DEPARTMENT OF TRANSPORTATION**National Highway Traffic Safety Administration**

[Docket No. NHTSA–2010–0053]

Visual-Manual NHTSA Driver Distraction Guidelines for In-Vehicle Electronic Devices

ACTION: Notice of Federal guidelines.

Figure 2: Drawing of Slide Presented by Toyota at NHTSA Technical Workshop¹³⁶

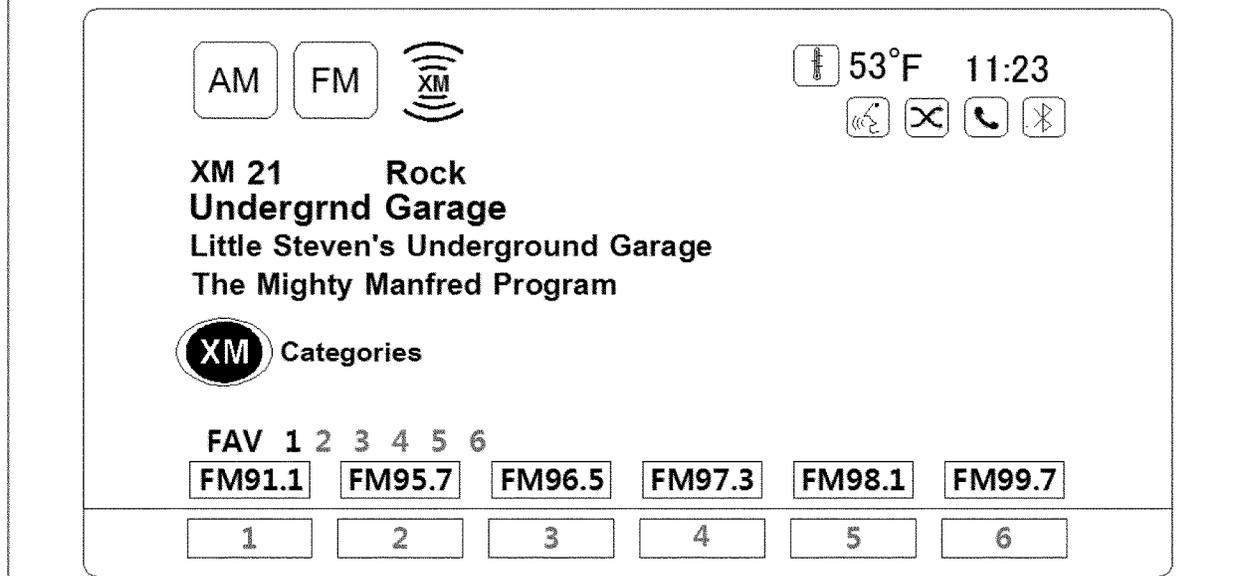
radio station program information (See Figure 2 below). He then asked:

five characters. So once we have the presets presented to the user, we can't give them any other information about what the radio is doing. If you pick any one element within this display, you quickly exceed a 30-character limit * * *¹³⁵

Where should the 30 character limit be applied to this display?

Mr. Foley then pointed out that the information conveyed by this display is easily grasped and that drivers do not have to read each individual letter to understand what is being transmitted by this display.
